Item Name: Crosstube Turning Detail

DART AEROSPACE LTD	Work Order:	105232
Description: Crosstube Assembly (412 High Aft)	Part Number:	D412-664-243
Inspection Dwg: D412-664-243 Rev: E		Page 1 of 2

DRAWING NO. D412-664-243	TITLE CROSSTUBE ASSEMBLY (412 HI AFT)	REV. E	DART AEROSPACE LTD ENGINEERING ORDER		D.E.O. NO. D412-664-243-E.4	SHEET NO. SHEET 1 OF 3	SCALE NTS
DRAWN [Signature]	CHECKED [Signature]	MFG. APPR. [Signature]	APPROVED [Signature]		DE APPR. [Signature]		
DATE 12.08.21	DATE 12.08.30	DATE 12.08.30	DATE 12/8/30		DATE 12.08-30

REMOVED ABRASION STRIP IN FAVOR OF A THIN LAYER OF PROSEAL 890. UPDATE INSTALLATION OF CHAFING SHIELDS AND REDUCE TORQUE TO 40-50 IN-LBS. THIS ENGINEERING ORDER SUPERCEDES DEO D412-664-243-E.1.

DRAWING NO. D412-664-243	TITLE CROSSTUBE ASSEMBLY (412 HI AFT)	REV. E	DART AEROSPACE LTD ENGINEERING ORDER	D.E.O. NO. D412-664-243-E-4	SHEET NO SHEET 2 OF 3	SCALE NTS
DRAWN 97	CHECKED	MFG. APPR.	APPROVED	DE APPR.		
DATE 12.08.21	DATE 12.08.27	DATE 12.08.29	DATE 12.08.29	DATE 12.08.29

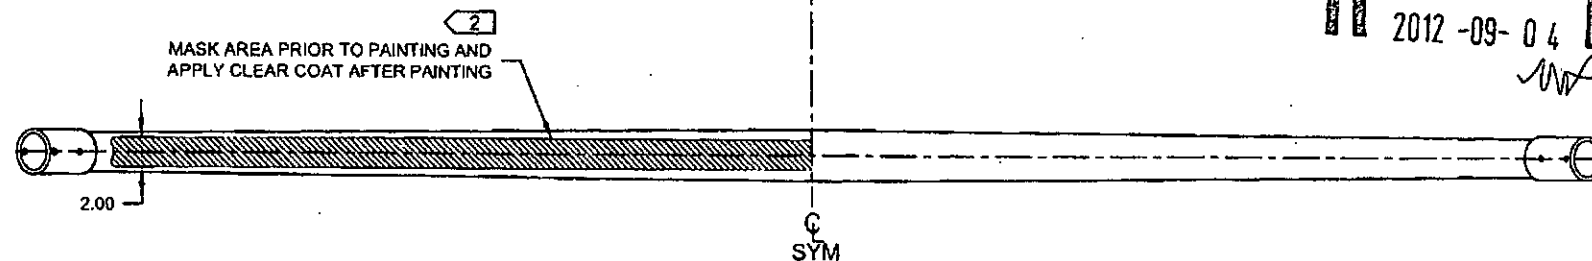
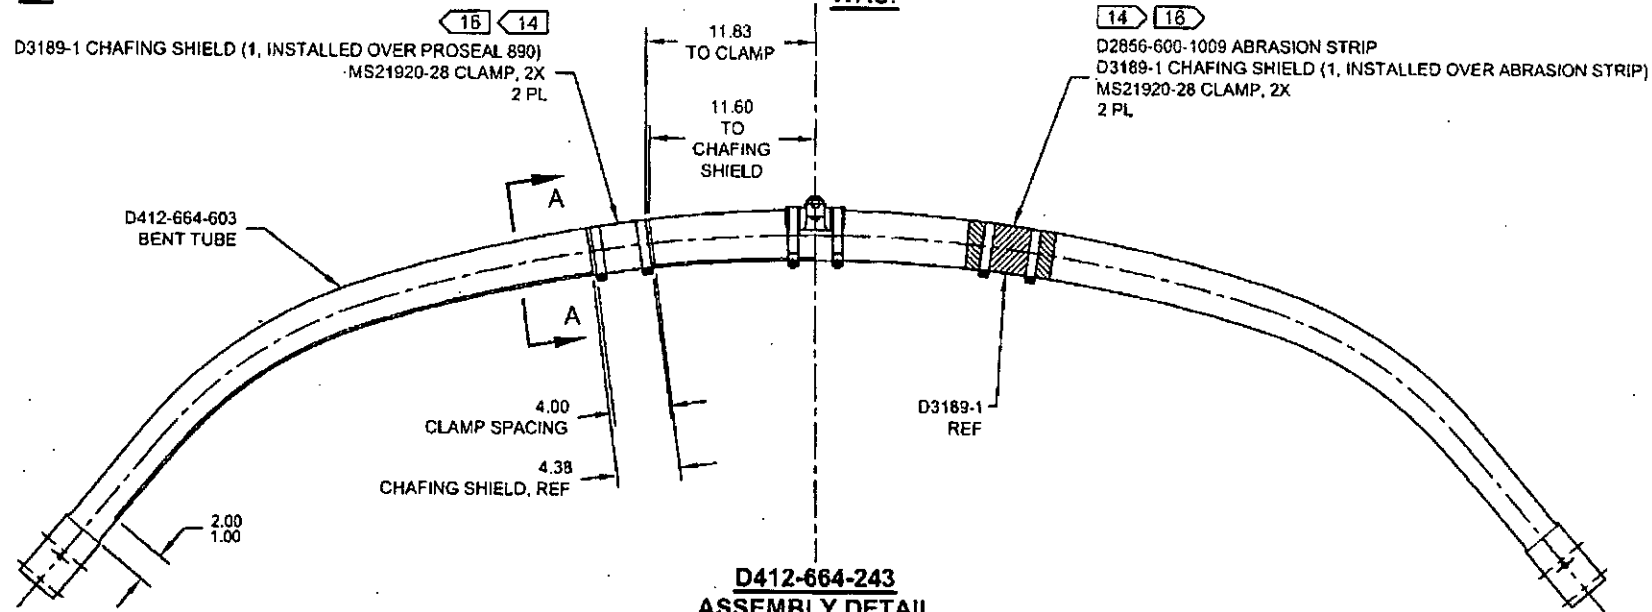
IS:

D3189-1 CHAFING SHIELD (1, INSTALLED OVER PROSEAL 890)
MS21920-28 CLAMP, 2X
2 PL

WAS:

D2856-600-1009 ABRASION STRIP
D3189-1 CHAFING SHIELD (1, INSTALLED OVER ABRASION STRIP)
MS21920-28 CLAMP, 2X
2 PL
